**DOCKET NO: A-98-49  
II-B1-17**

**TECNICAL SUPPORT DOCUMENT FOR SECTION 194.27:  
SANTOS COMPUTER CODE  
IN WIPP PERFORMANCE ASSESSMENT**

**U. S. ENVIRONMENTAL PROTECTION AGENCY  
Office of Radiation and Indoor Air  
Center for the Waste Isolation Pilot Plant  
1310 L St., NW  
Washington, DC 20005**

**March 2005**

Figure 5. Detail of the deformed disposal room with waste for  $f=0$ :  
at 300 years (Figure 5a) and at 10,000 years (Figure 5b)  
(from Stone 1997a, Figures 9 and 10).

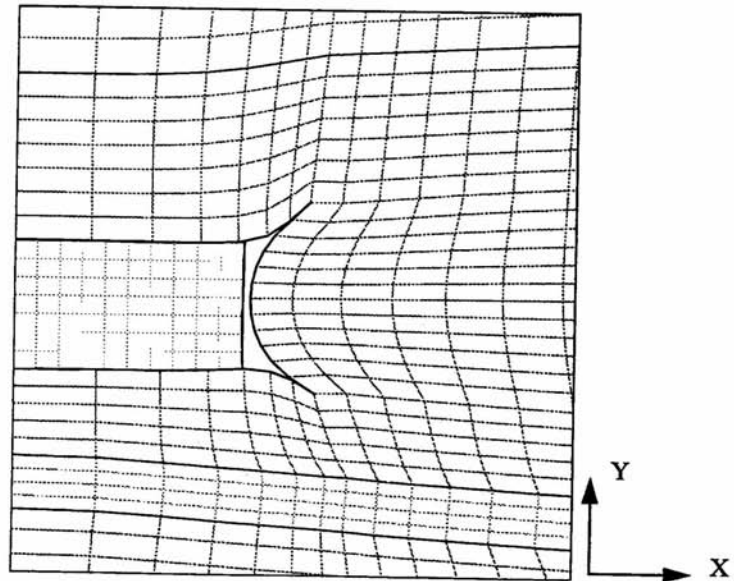
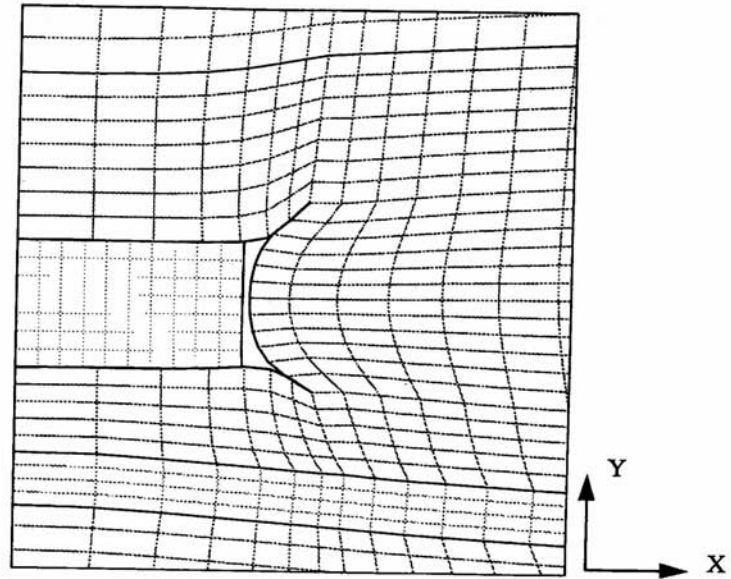
Figures 5a and 5b show the SANTOS-predicted, deformed waste room after 300 and 10,000 years for the case of no gas generation ( $f = 0$ ; Stone 1997a, Figures 9 and 10). As shown in the illustrations, the free space around the waste closes relatively quickly. The waste is essentially fully contacted within 300 years and undergoes relatively little subsequent volume reduction. Figures 6a and 6b show the SANTOS-predicted, deformed waste room after 300 and 10,000 years for gas production at half the reference case rate ( $f = 0.5$ ; Stone 1997a, Figures 11 and 12). Here the gas pressure becomes sufficiently high to allow essentially no further waste volume reduction after 300 years, and to reduce horizontal wall deformation to the point that no significant horizontal back pressure is provided by the waste for 10,000 years. This suggests that waste porosities can remain high and stresses on the waste can remain low when gas is produced in the repository.

Figure 7. Pressure histories for various values of the gas generation parameter  $f$  (from DOE 2004, Appendix PA, Attachment PORSURF, Figure PORSURF-3).

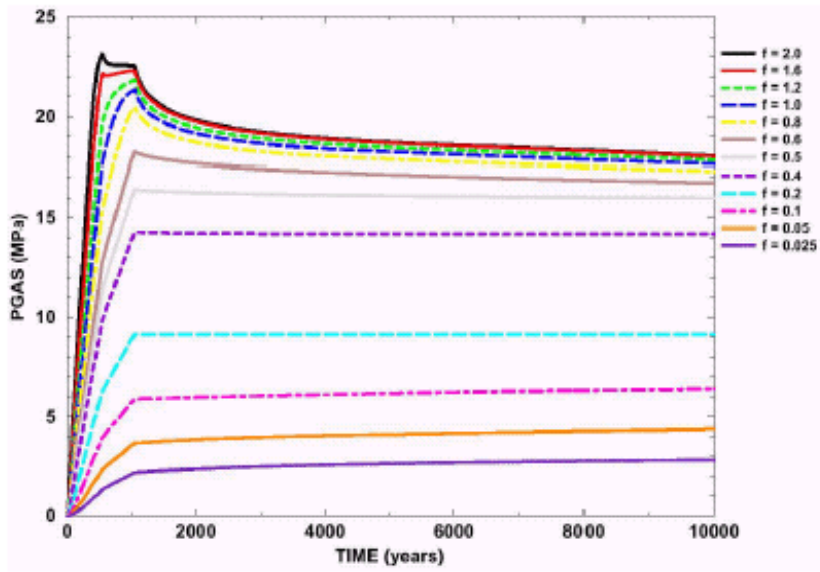
The foregoing conclusion is supported by the results on Figures 7 and 8. For purposes of generating the porosity surface, gas production in SANTOS is assumed to cease after 1,050 years (Stone 1997a, p. 4). Figures 7 and 8 show that for  $f = 0.5$ , after about 1,000 years the waste room gas pressure remains relatively constant at about 16 MPa and the porosity remains approximately constant at about 0.6. This gas pressure is more than sufficient to support the lithostatic pressure of about 15 MPa (F.D. Hansen et al 2003, Section 4.5). Of greater interest is the predicted porosity, shown in Figure 8, of about 0.235 after 10,000 years with no gas production ( $f = 0$ ). Considering the aforementioned initial waste porosity of 0.681, a reduction to 0.235 represents a volume strain of about 0.87. From Figure 1, this strain is equivalent to an average applied pressure of about 4 MPa, which is less than the lithostatic equilibrium pressure of about 15 MPa. This indicates that average stresses on the waste are predicted to remain well below lithostatic after 10,000 years, even with no gas pressure in the room. It is also noted that for the higher gas generation rates, generally for  $f > 0.5$ , the porosity history curves in Figure 8 show an increase in waste room porosity between about 500 and 1,000 years corresponding to room dilation.

Figure 9. WIPP convergence plots for E790 Drift-S2350, Room 3, Panel 2  
 (from TEA 2005; *SANTOS and Porosity Surfaces*, meeting handout by Bill Thompson, Golder Associates)

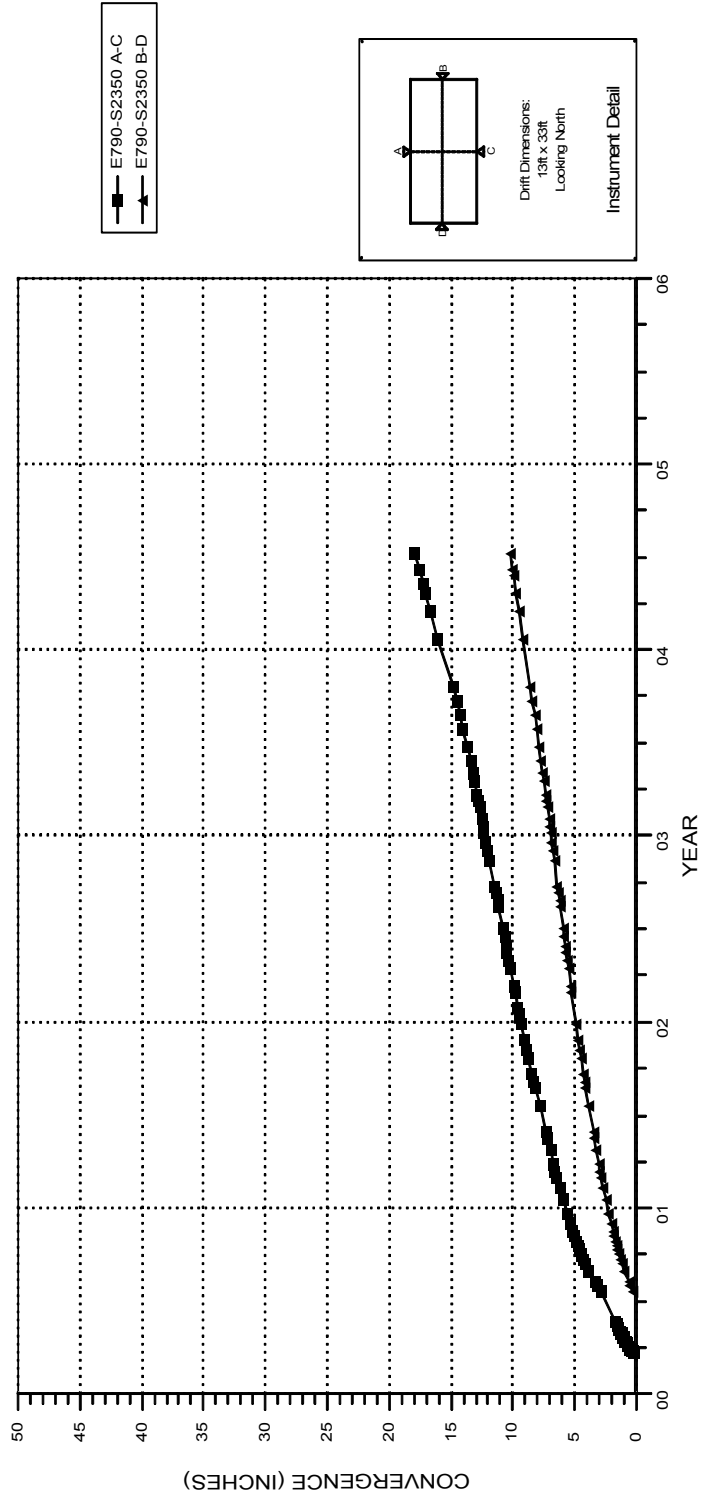
The foregoing considerations suggest that horizontal wall movement into the room would be less rapid than vertical roof and floor movement, even at early times. This expectation has been confirmed by convergence measurements in test drifts at WIPP, as illustrated by Figures 9 and 10 (EPA 2005, *SANTOS and Porosity Surfaces*, meeting handout by Bill Thompson, Golder Associates). The greater span of the roof and floor and the compounding effects of model element contact in the corners of the room provide an adequate qualitative explanation for the SANTOS model prediction of a lower horizontal stress in the walls, however the true magnitude of that stress and the accuracy of the related long-term, secondary halite creep rate after 10,000 years remain uncertain. Although the WIPP field measurements confirm the predicted short-term creep behavior of the halite, they do not address the accuracy of the very slow, long-term rate of return to a lithostatic stress state predicted by SANTOS. The conceptual model of a fairly rapid rate of return to lithostatic equilibrium conditions appears to have been based on recent and historic observations of room closure and halite encapsulation occurring within time frames of tens to hundreds of years and the assumption that the observed closure is accompanied by an equally rapid return to equilibrium stress conditions. However, the room closure observations have not been accompanied by in situ stress measurements and the rate of stress buildup accompanying room closure is therefore uncertain.
